**City of Greensboro Planning Department
Zoning Staff Report
February 13, 2006 Public Hearing**

Item: J
Location: 837, 841 & 843 Roberson Comer Road (South side of Roberson Comer Road east of Prestbury Drive and north of the terminus of Tuliptree Drive)

From: RS-12
To: CD-RM-8

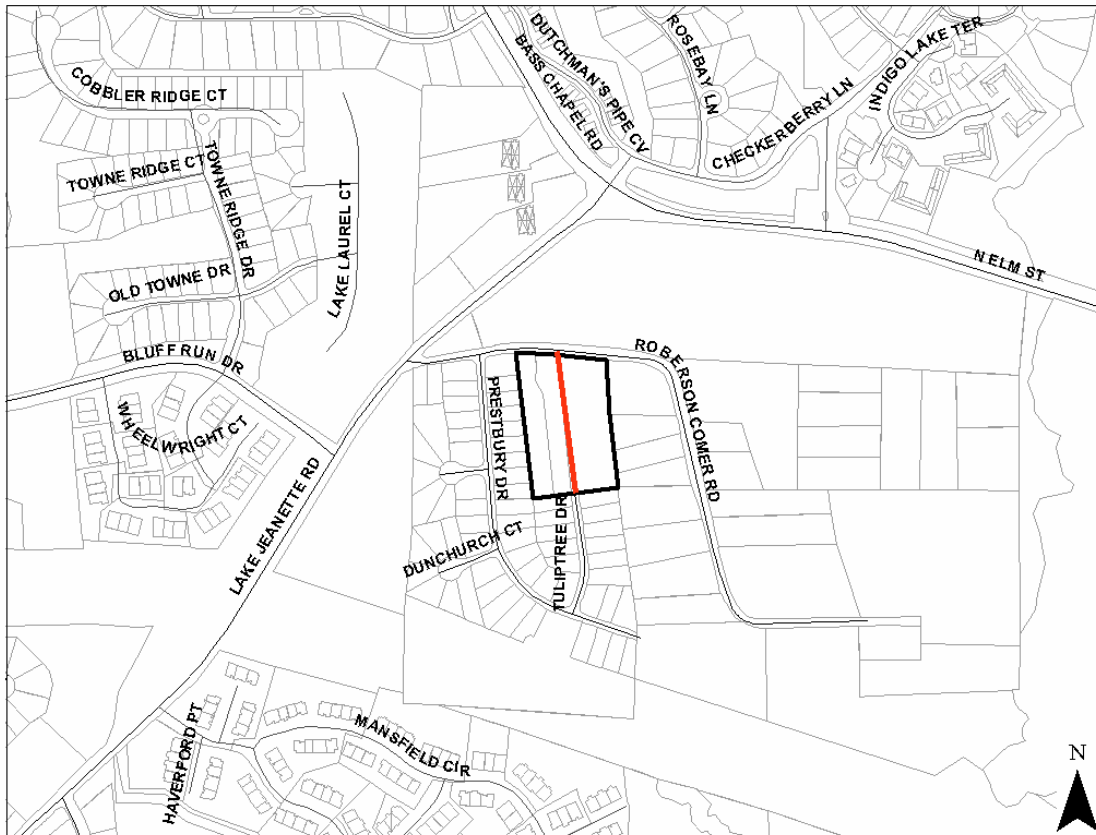
The location of this neighborhood is extremely close to a fire station. However, due to the layout of these streets a connection as shown would reduce response times and provide emergency vehicles a secondary means of access. On dead end streets Fire Dept. access may be eliminated for secondary units if feeder hose is laid down the street.

The block along the northeast side of Preswick Drive (between the western and eastern portions of Roberson Comer Road) is approximately 1,900 feet. With the connection of the through-street the block would be divided into two segments, one at approximately 1,150 feet and one at approximately 750 feet. The connection would create a situation that fully complies with the Development Ordinance. **Therefore, the connection is recommended.**

The current block perimeter measures approximately 3,620 feet. With the street connection the current block would be divided into two blocks, one with a perimeter of approximately 2,550 feet and the other with approximately 3,100 feet. Although the existing block perimeter complies with the requirements of the Ordinance, having the street connection would create a situation that meets the spirit and intent of the provision than not having the connection. **Therefore, the connection is recommended.**

"Tuliptree Drive" cul-de-sac would be approximately 500 feet. The connection would eliminate the cul-de-sac. **Therefore, the connection is recommended.**

The proposed street extension/connection is proposed to be local residential street, and is not anticipated to have any impact on traffic congestion level within the area.

The proposed street connection will provide pedestrian and bicycle connection between existing and proposed residential streets.

Water Resources: No streams were found onsite. The proposed layout wouldn't adversely affect any drainage way.

GDOT: The proposed street connections will improve the routing and delivery of goods and public services such as solid waste collection, mail/package deliveries, school bus routing, and water/sewer line connections.

Environmental Services: If no through street is developed a permanent structure will be required. Solid waste does not have an alternative to backing at least 75 feet or more. Most services are provided with a single operated vehicle. Blind spots are associated with these vehicles.

Fire Department: Fire code requires any street longer than 150' to have a permanent turn around. The Greensboro Fire Department requires a minimum Cul-De-Sac diameter of 65', or a T/L – shaped turn around w/ the minimum branch length of 50'.

Based on the above information staff sees no reason not to recommend the extension/connection of Tuliptree Drive.
